**Responses to Questions and Comments for Which the I-495 Express Lanes Northern Extension (495 NEXT) Project Team Indicated Complementary Responses Would be Provided
495 NEXT May 26, 2022 Meeting Related to Live Oak Drive Design Plans**

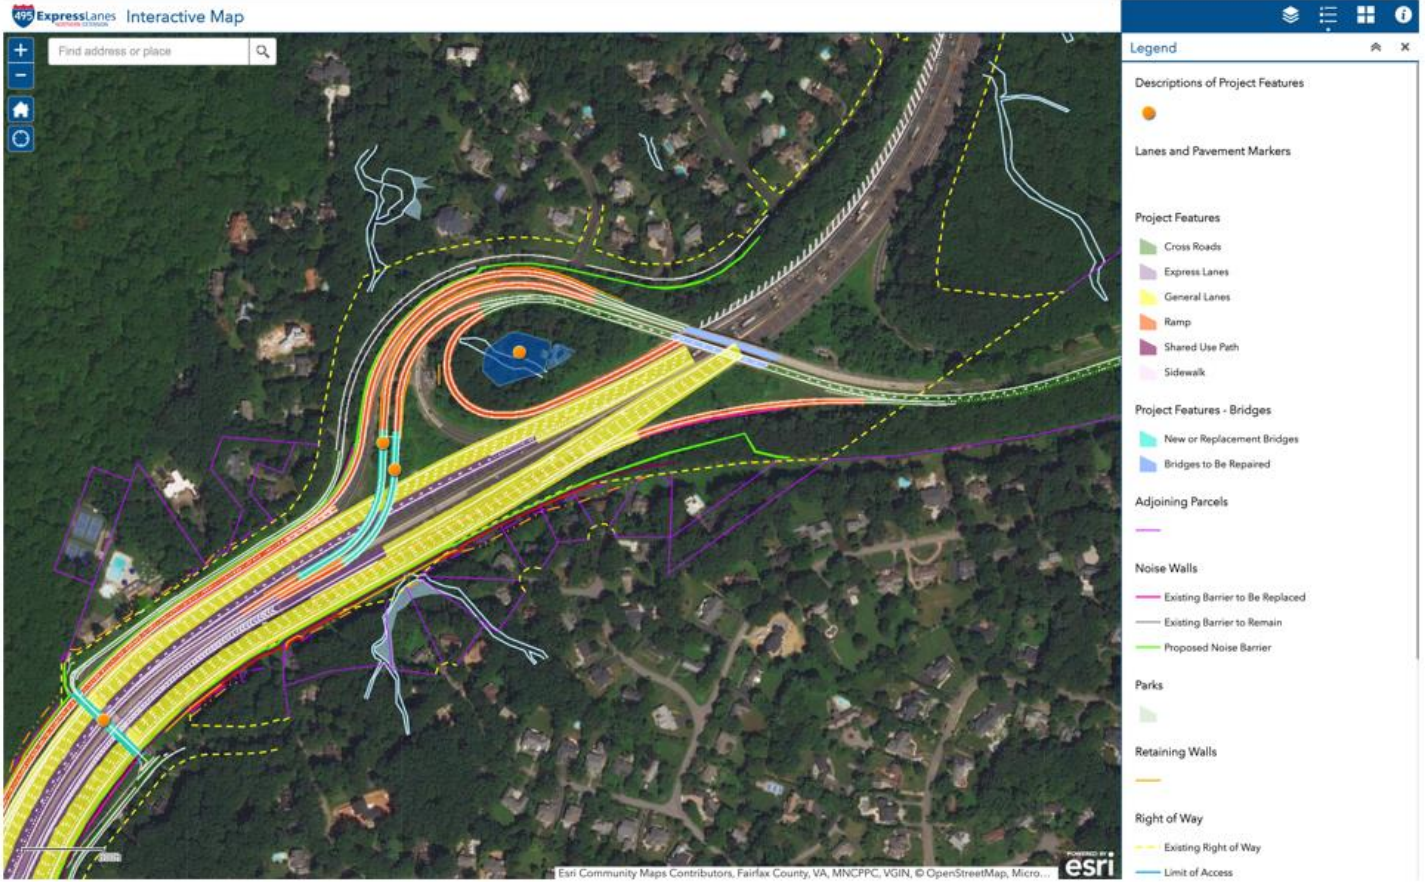
13. Please provide detailed information about the landscaping plan along Live Oak Drive.

Locations of landscaping and tree replacement, in accordance with the project Technical Requirements, will be developed in 2023 at which time locations will be identified.

Attachment 1
Elevations for Proposed GWMP Associated with 495 NEXT Project
Exhibit

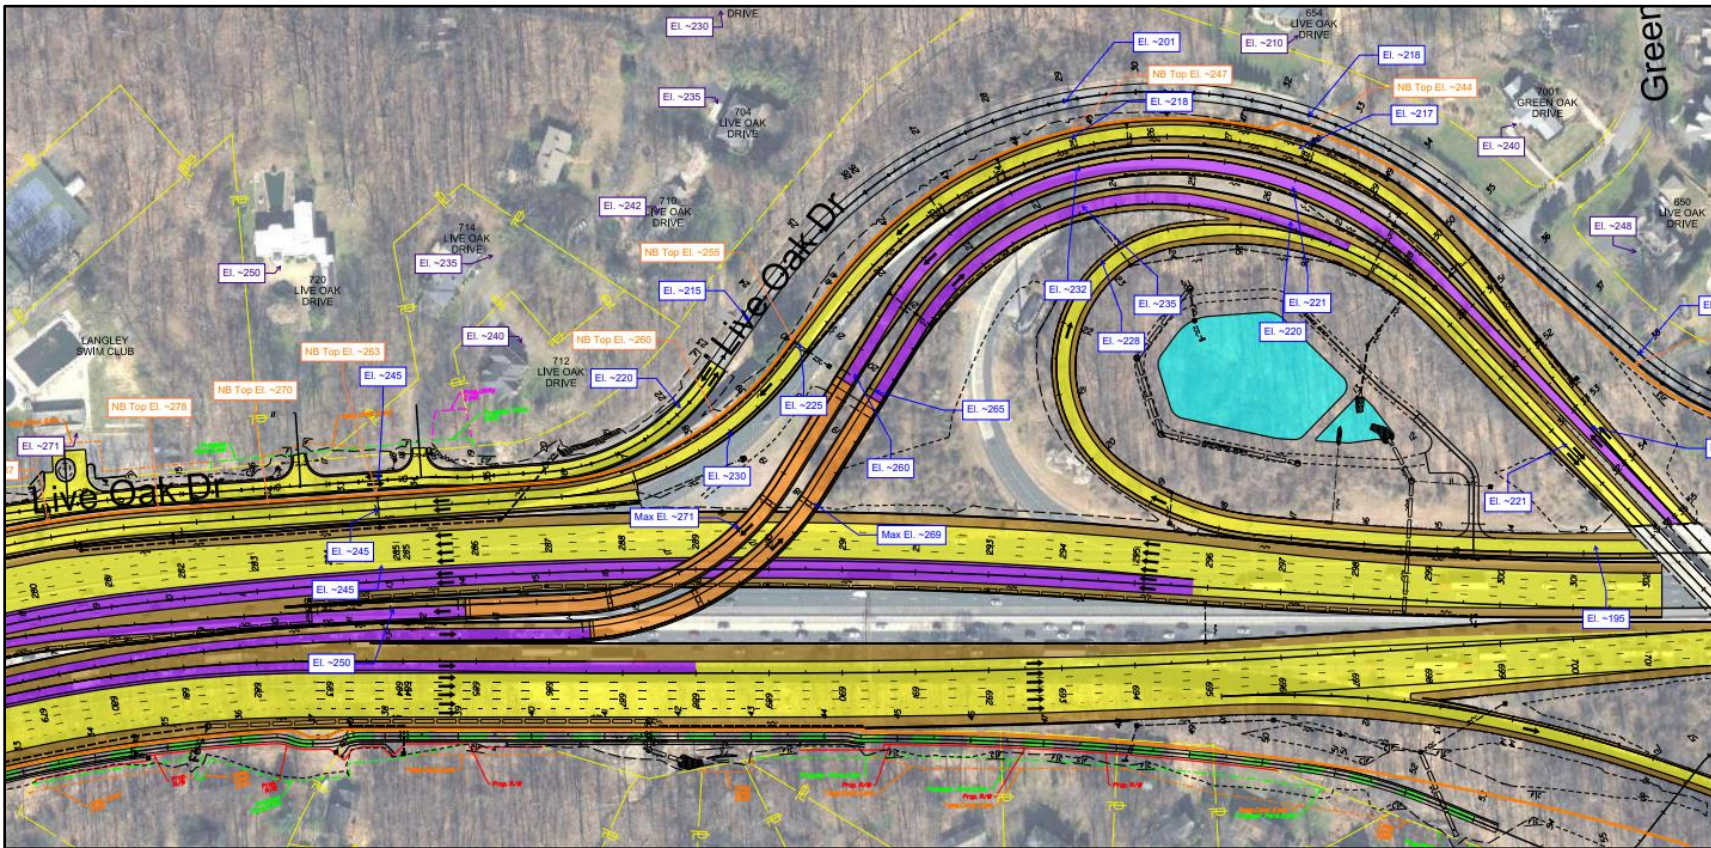
6. How tall will the sound barriers in the vicinity of Live Oak Drive be and will the ramps from GW Parkway be taller than the barriers?

The preliminary noise analysis (EA Preliminary Noise Technical Report, pages 56 – 57), indicates that the height of the proposed noise walls (Barrier 10 and 10 [ext]) range from 8 to 26 feet. These heights may change based on the Final Noise Analysis. Please refer to Attachment 1: Elevations for Proposed GWMP Associated with 495 NEXT Project. This exhibit is based on design information shared at the May 26th Live Oak Meeting. Even though the exhibit is not inclusive of every elevation along Live Oak Drive, it provides the general sound barrier elevations along Live Oak Drive and the proposed elevations of the ramps associated with the 495 NEXT project.

Line of Sight for Proposed Ramps at George Washington Memorial
Parkway Ramp Exhibit

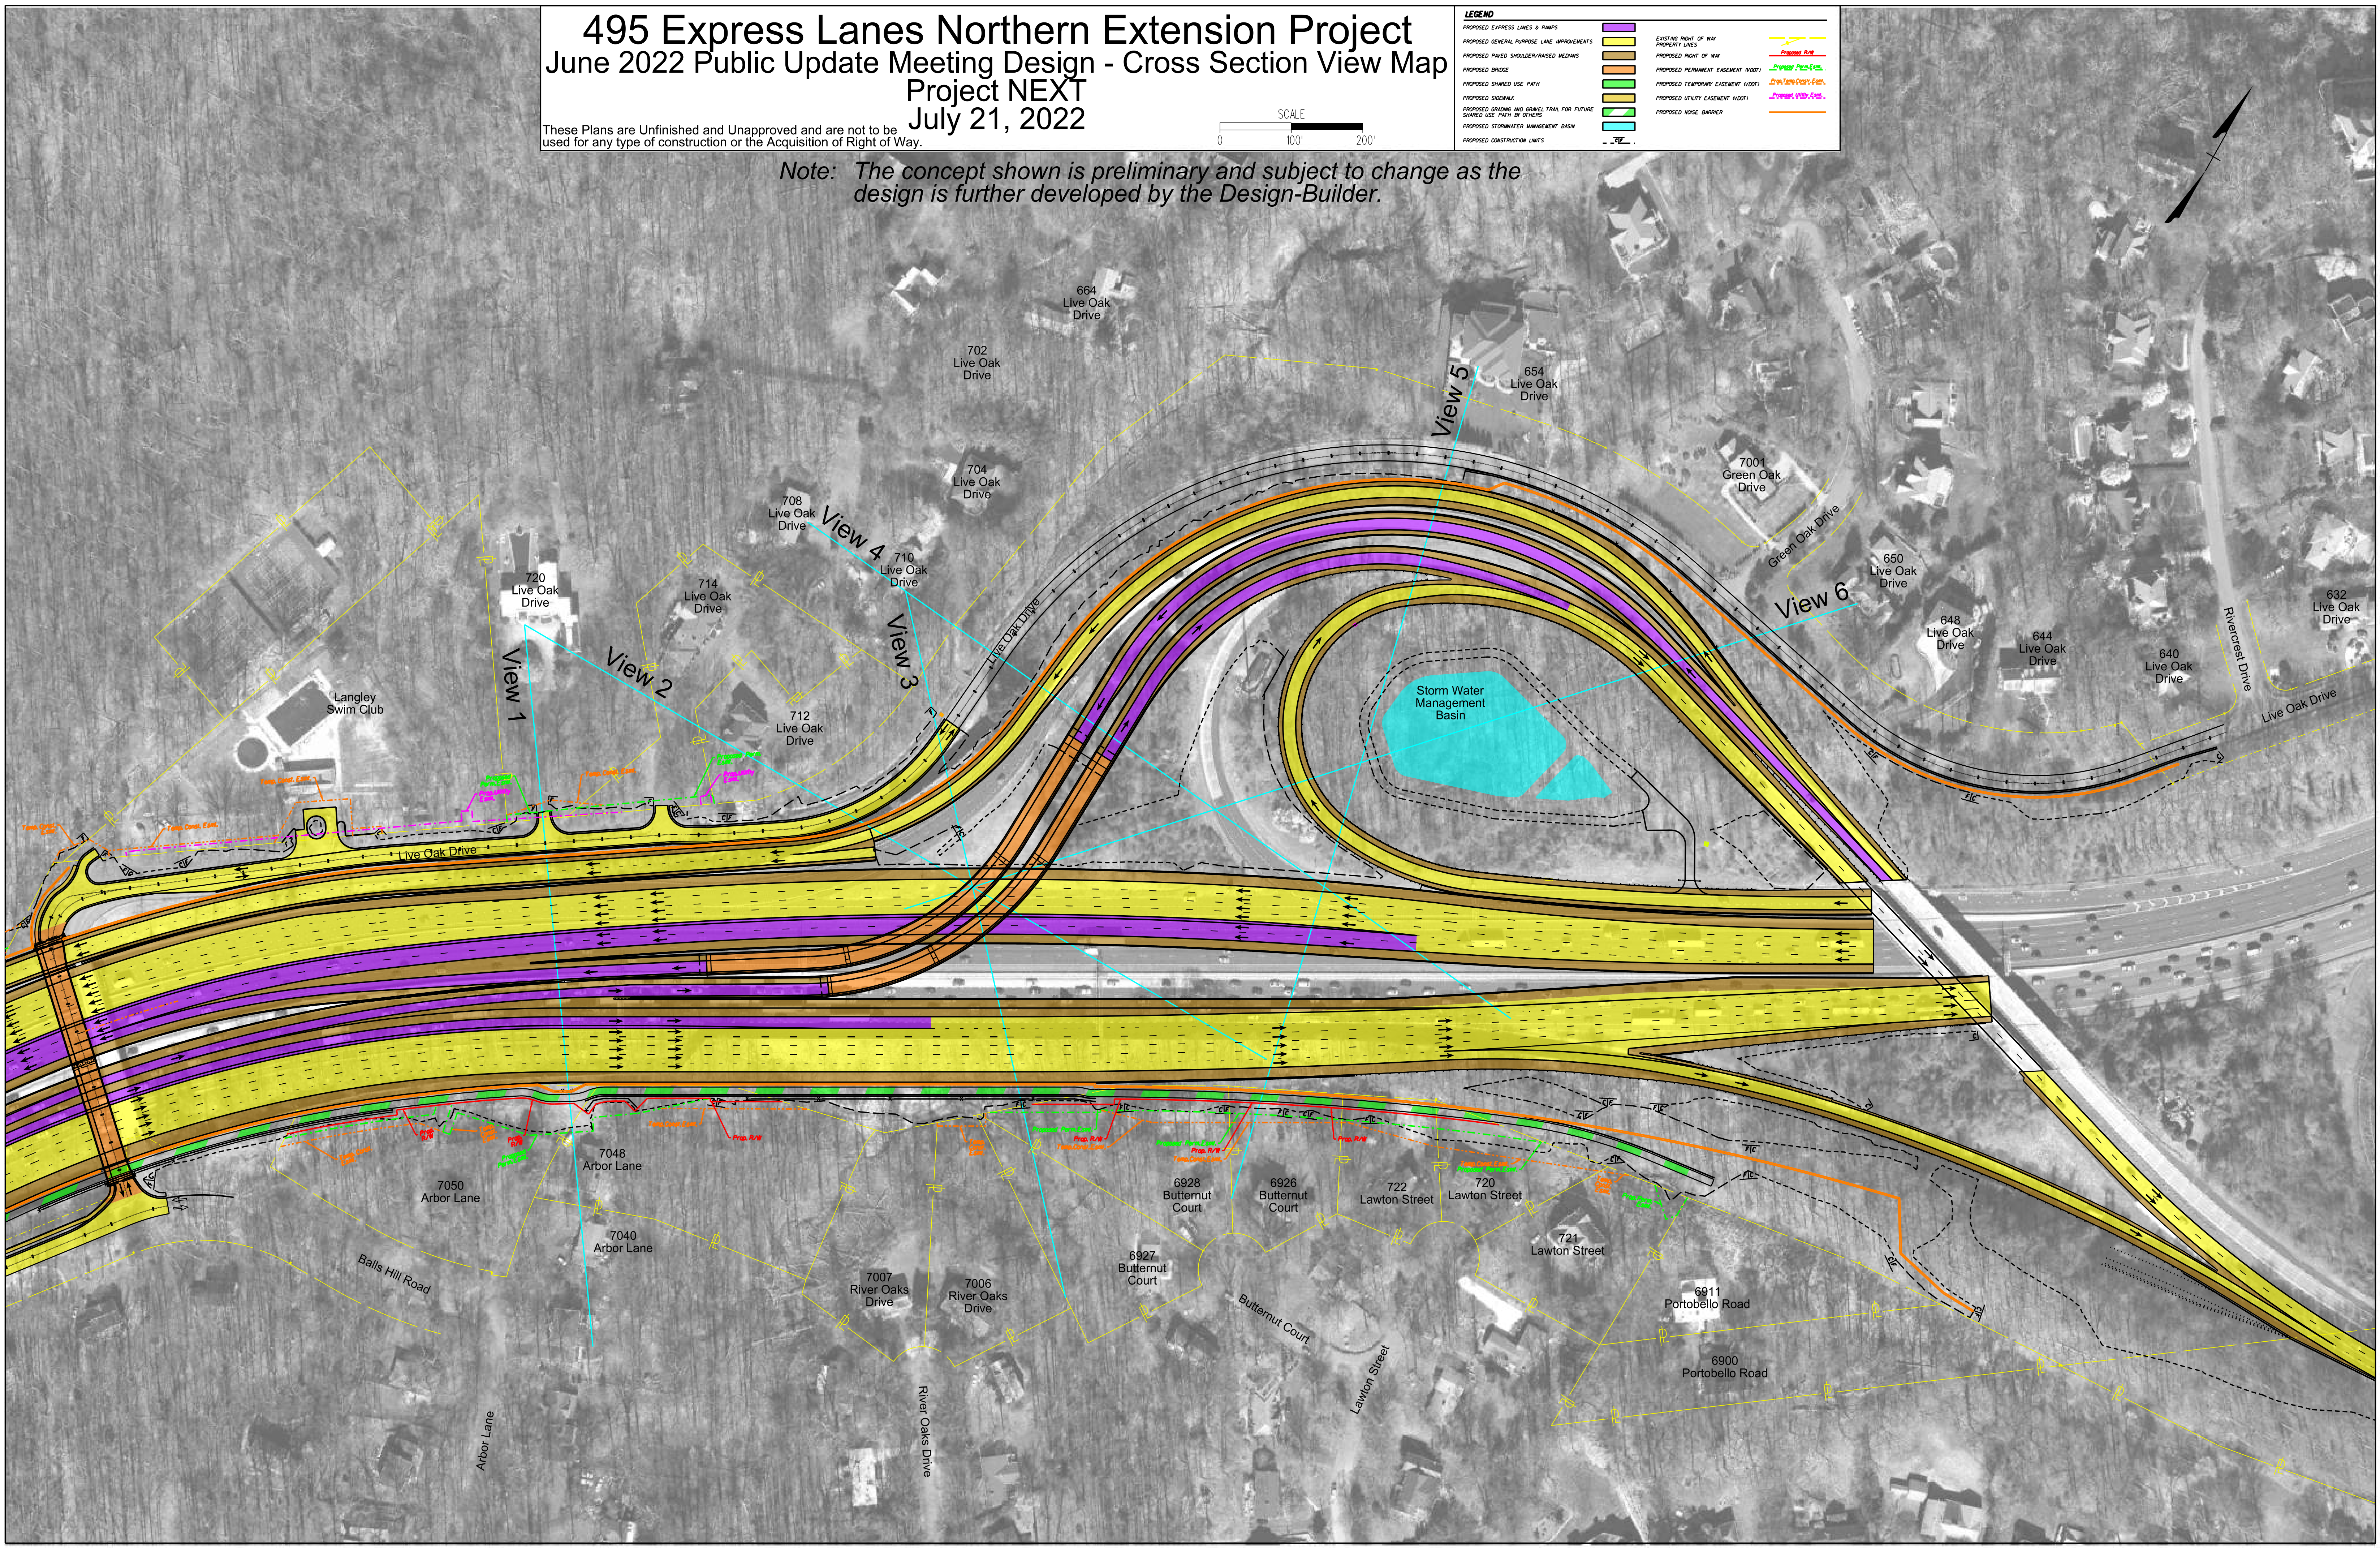
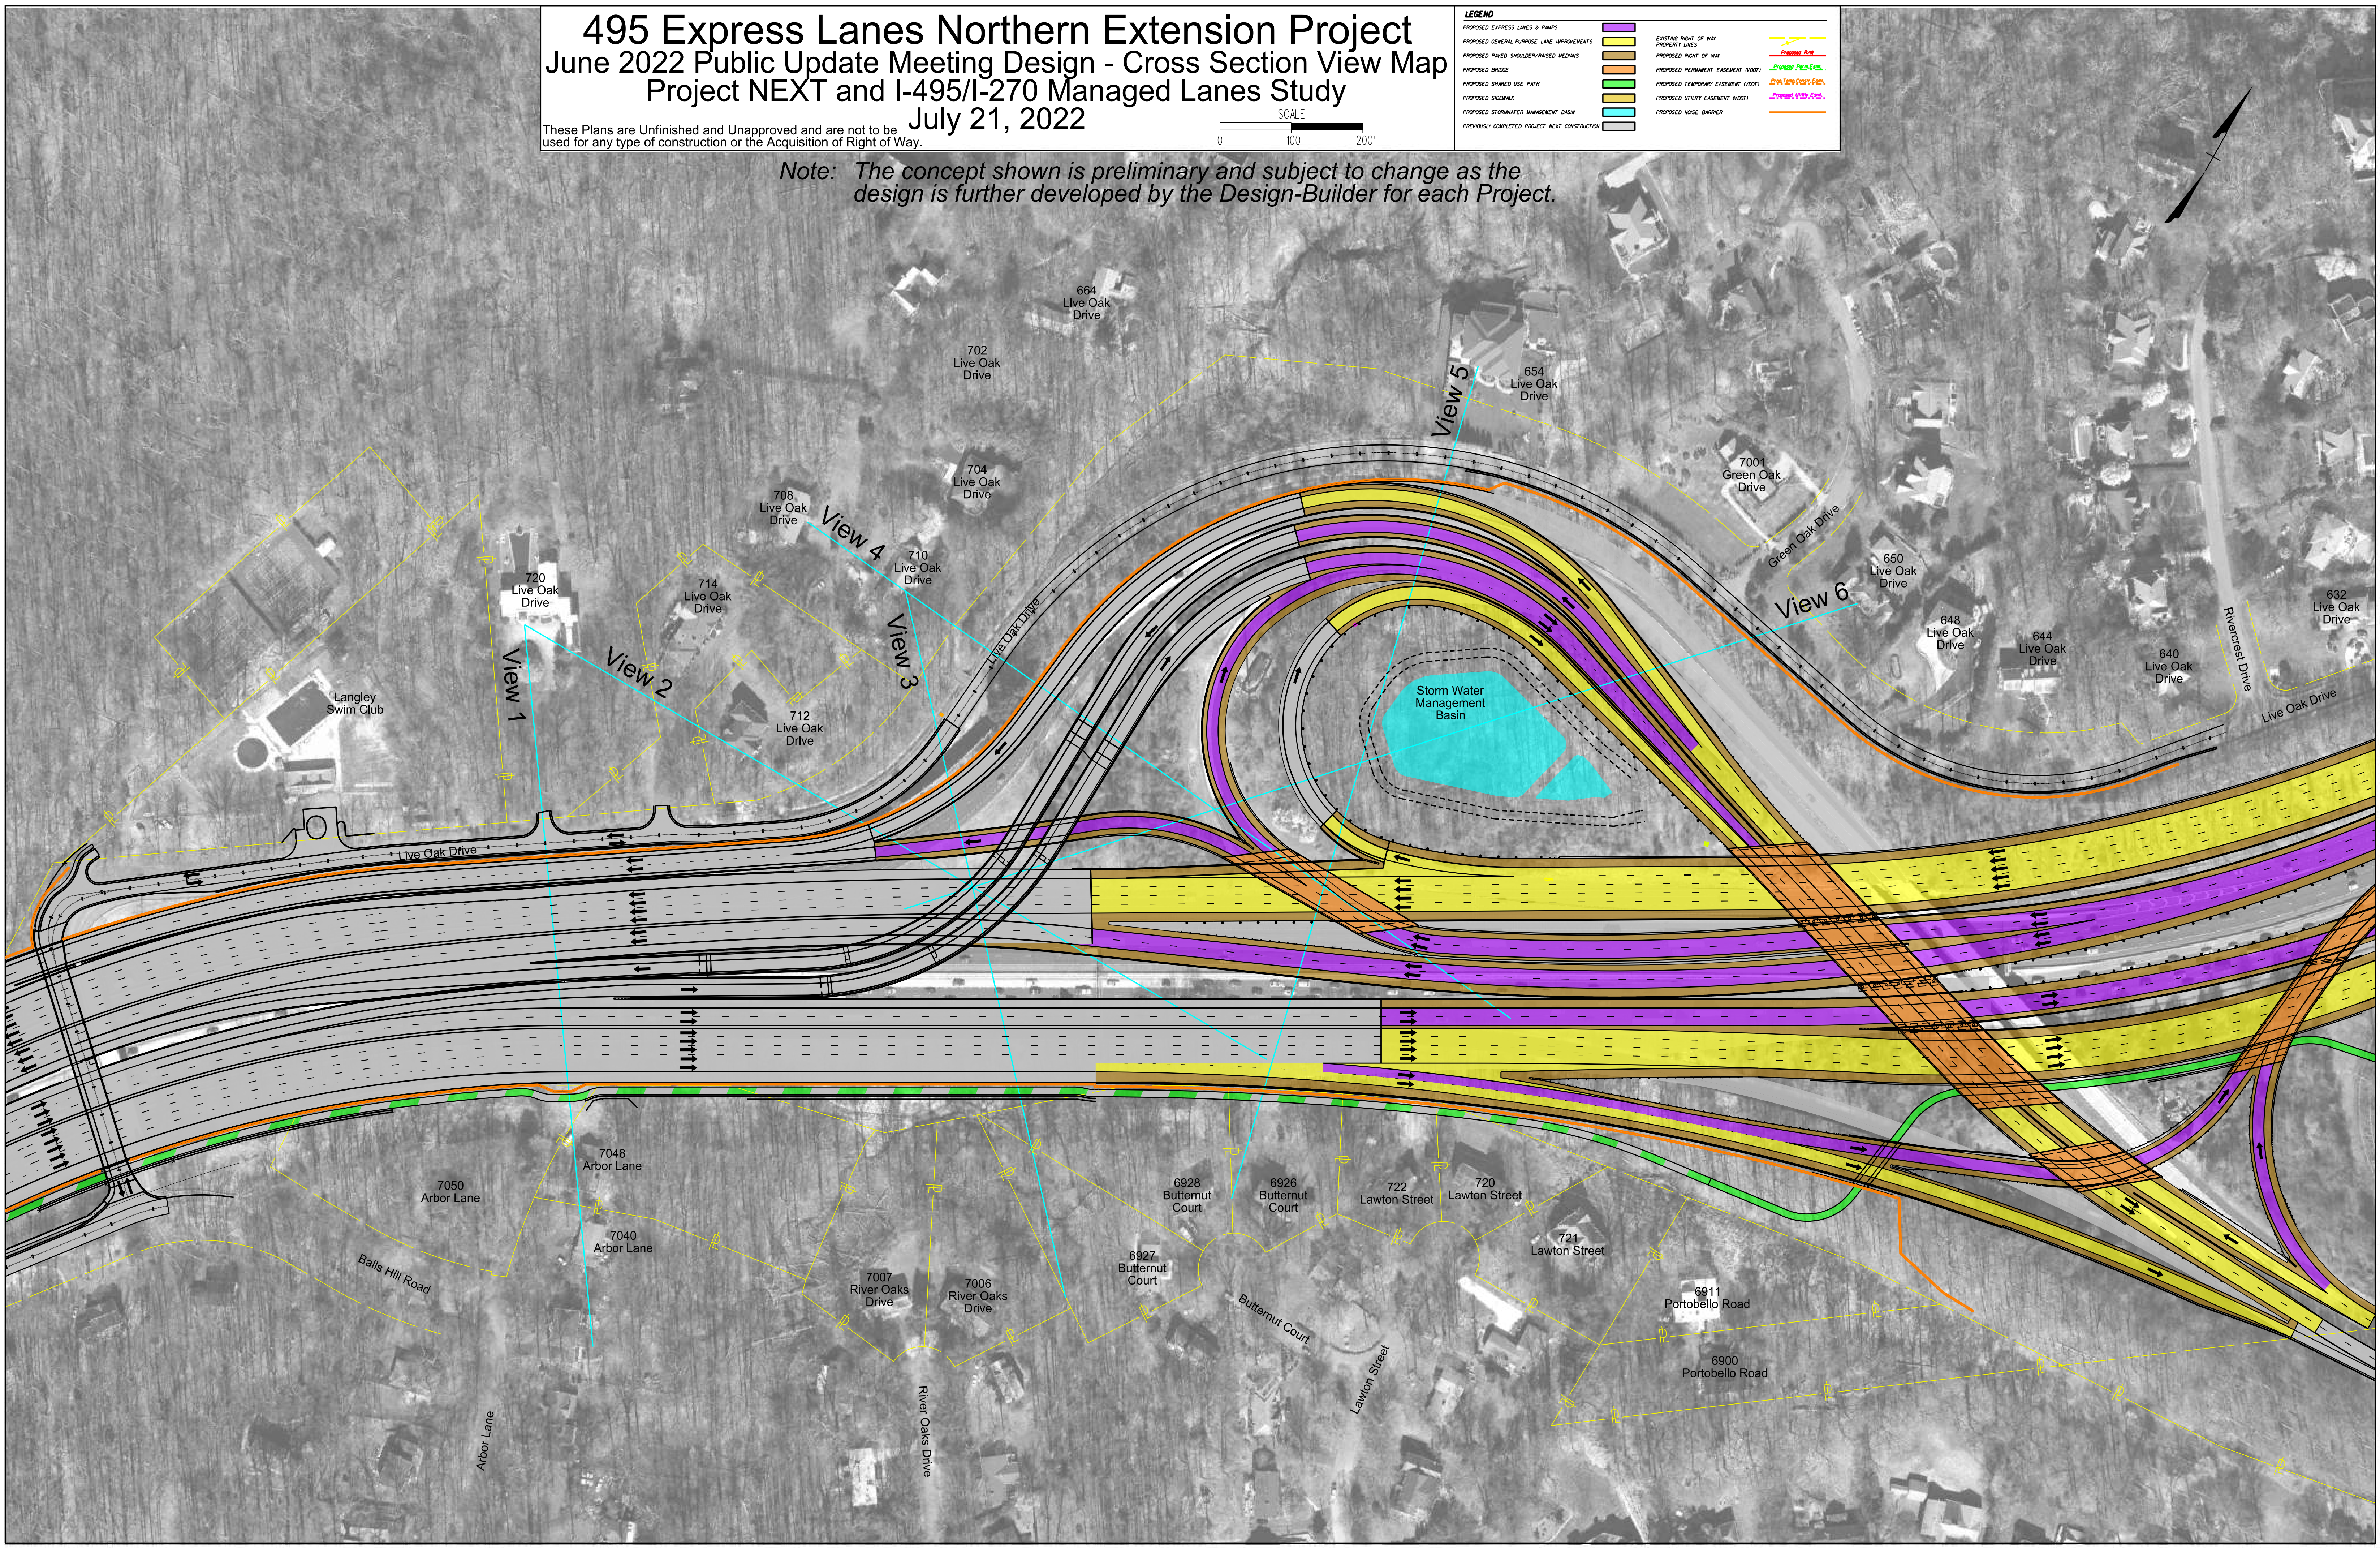
7. Is there a visualization of what the project modifications will look like from Live Oak Drive?

The Live Oak Drive visualizations can be found at http://www.495northernextension.org/documents/project_next_-_live_oak_drive_visualization_2021_01_21.pdf. Additionally, VDOT has prepared the Line of Sight Exhibits in Attachment 2 that depict representative perspectives along Live Oak Drive.
